CITY PLAN COMMISSION**THURSDAY, MARCH 23, 2023****FILE NUMBER:** S223-099**CHIEF PLANNER:** Mohammad H. Bordbar**LOCATION:** Garland Road / State Highway No. 78 at terminus of Centerville Road**DATE FILED:** February 24, 2023**ZONING:** PD 1095**PD LINK:** currently not available**CITY COUNCIL DISTRICT:** 9 **SIZE OF REQUEST:** 7.257-acres**MAPSCO:**38F**APPLICANT/OWNER:** Shoreline Church Dallas

REQUEST: An application to create one 7.257-acre lot from a tract of land in City Block 5361 on property located on Garland Road / State Highway No. 78 at terminus of Centerville Road.

PRELIMINARY PLAT
STANDARD AT

SHORELINE ADDITION
LOT 1A, BLOCK 5361
BEING A PART OF CITY BLOCK 5361
IN THE MCNEENEY AND WILLIAMS

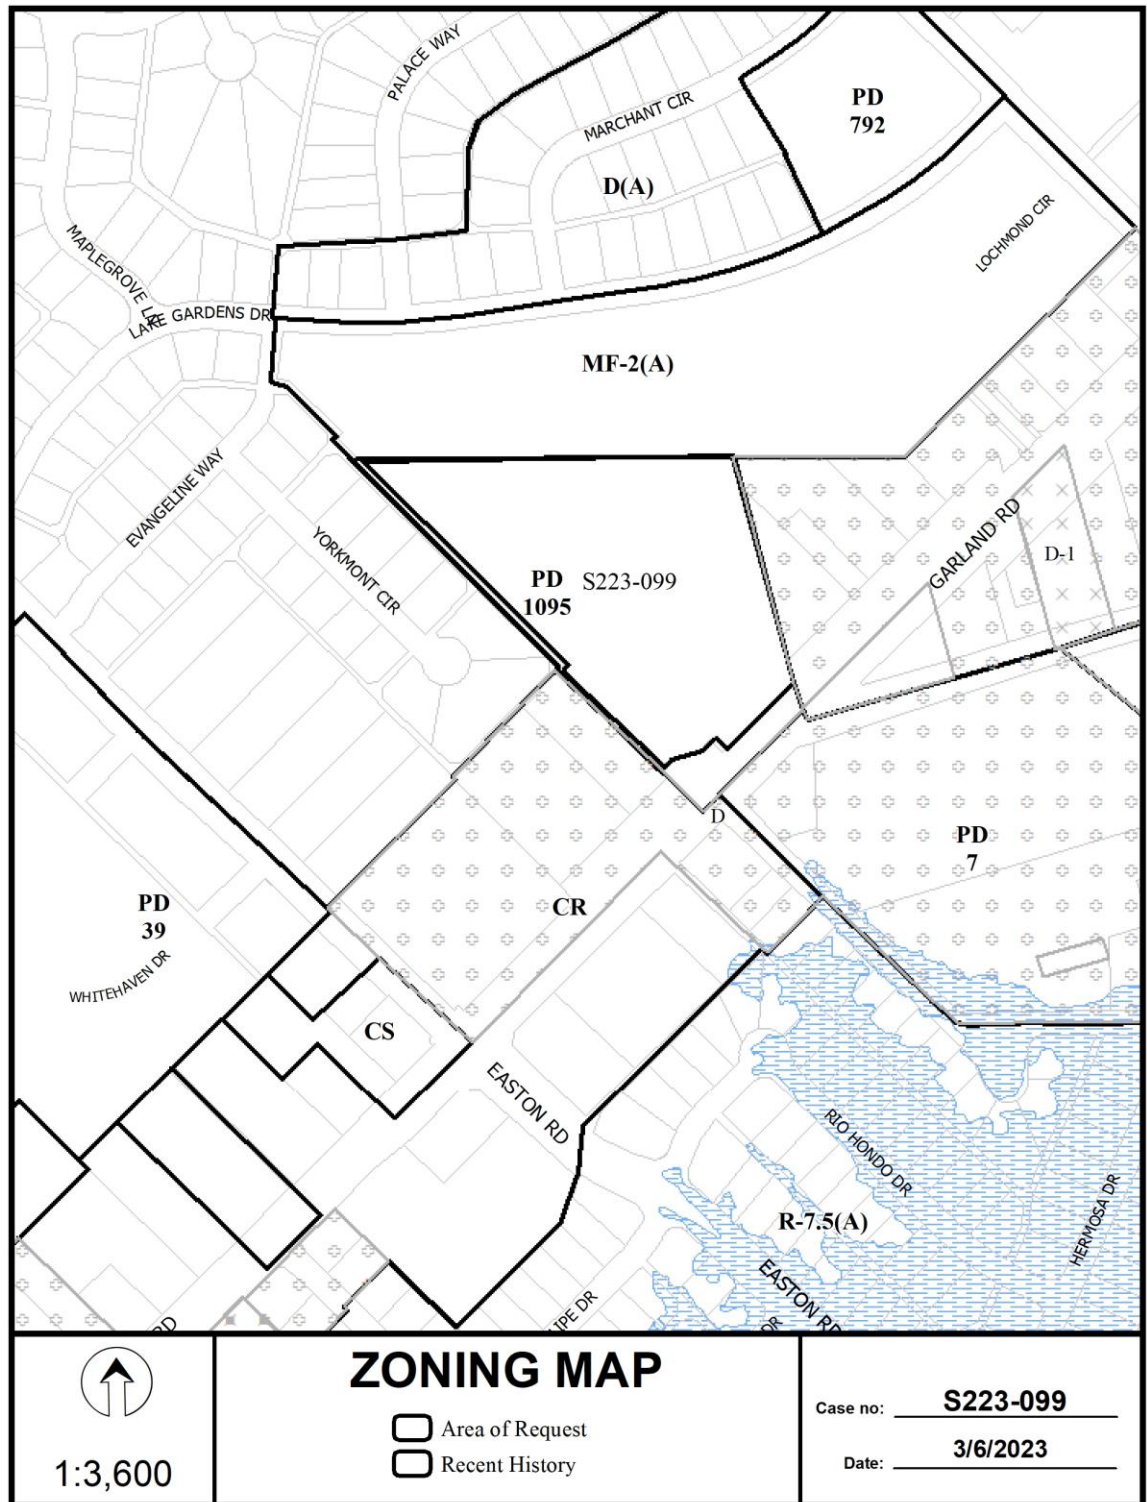
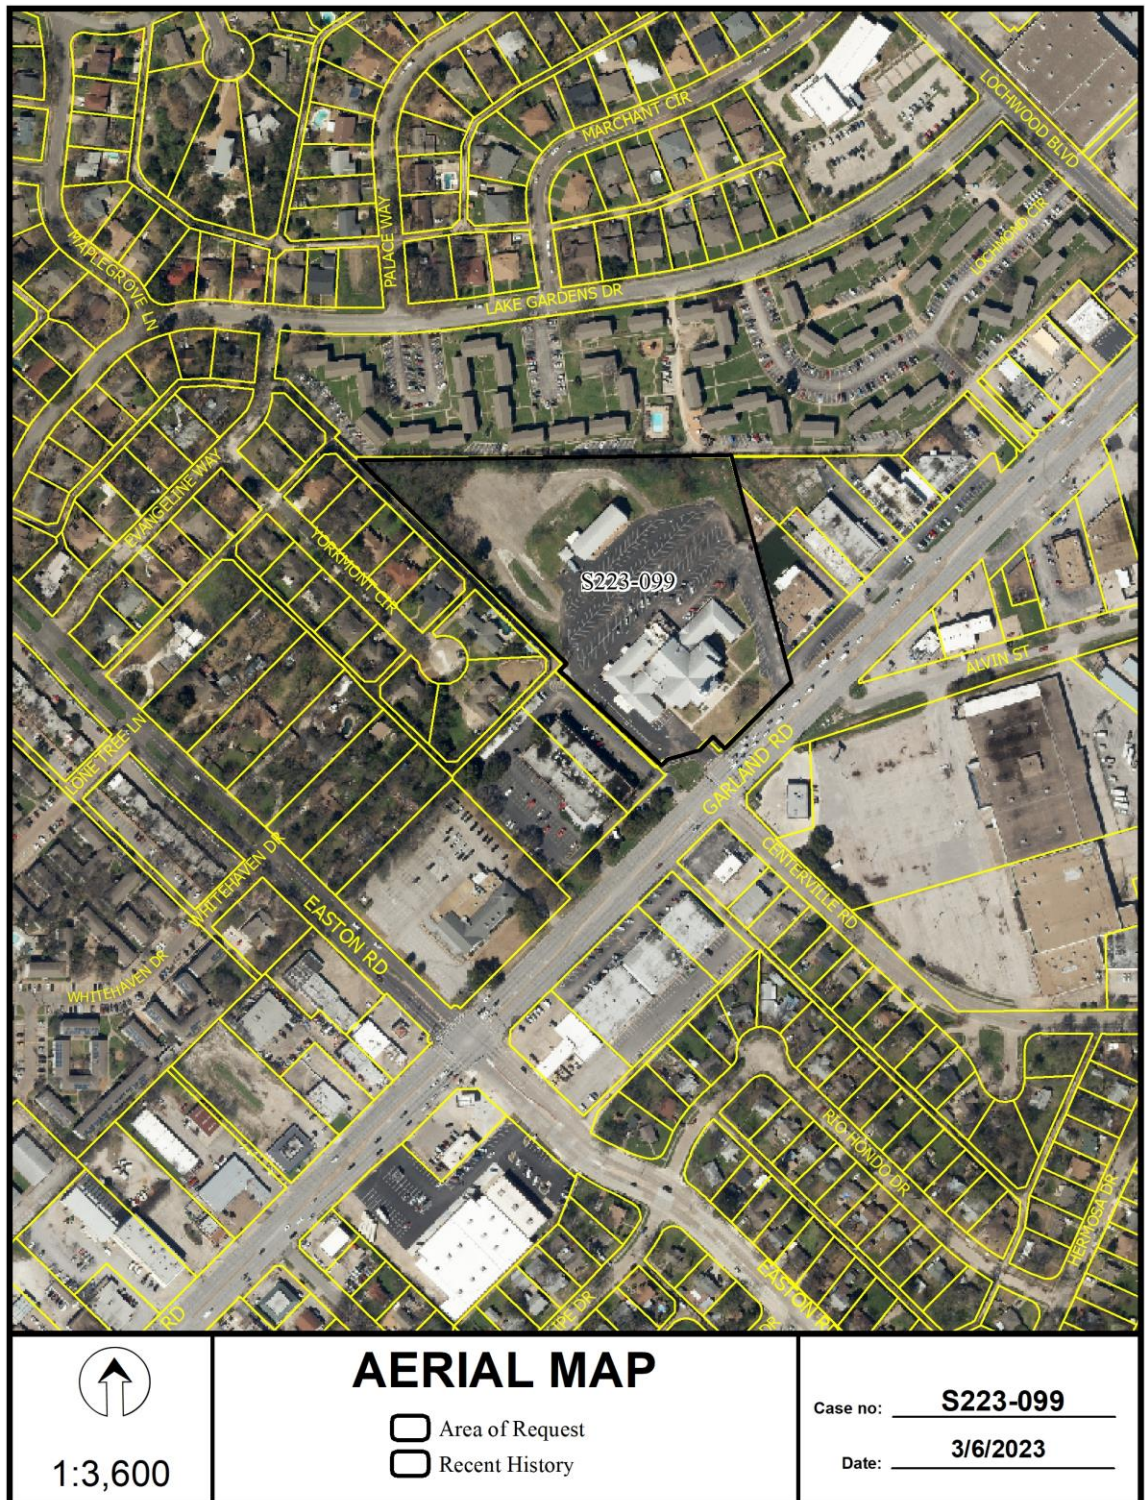
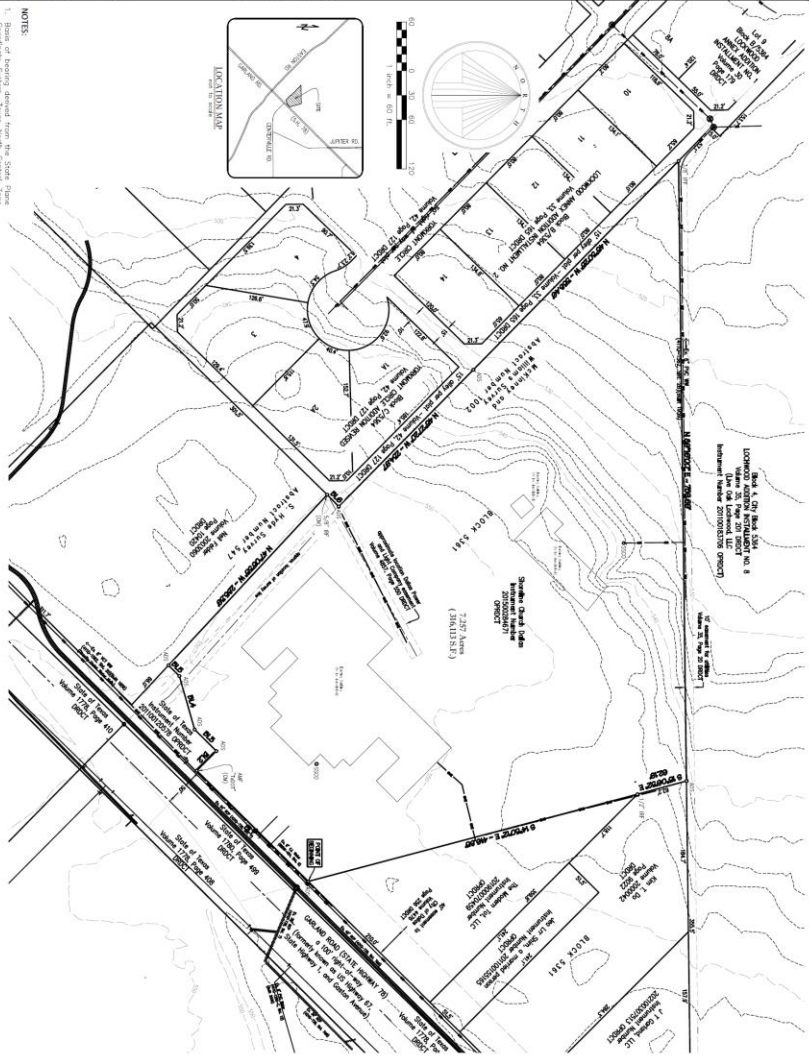
18. Prior to final plat, submit a completed final plat checklist and all supporting documents.
19. On the final plat, show distances/width across all adjoining right-of-way. Platting Guidelines.
20. On the final plat, show recording information on all existing easements within 150 feet of the property.
21. On the final plat, show all additions or tracts of land within 150 feet of the property with recording information. Platting Guidelines.

25. On the final plat, add label for “Centerville Road”. Section 51A-8.403(a)(1)(A)(xii)
26. On the final plat, change “Garland Road” to “Garland Road / State Highway No. 78”. Section 51A-8.403(a)(1)(A)(xii).
27. On the final plat, identify the property as Lot 1 in City Block Y/5361. Ordinance 1A, Page 131 pages 131-148, Section 2 (passed August 13, 1872).
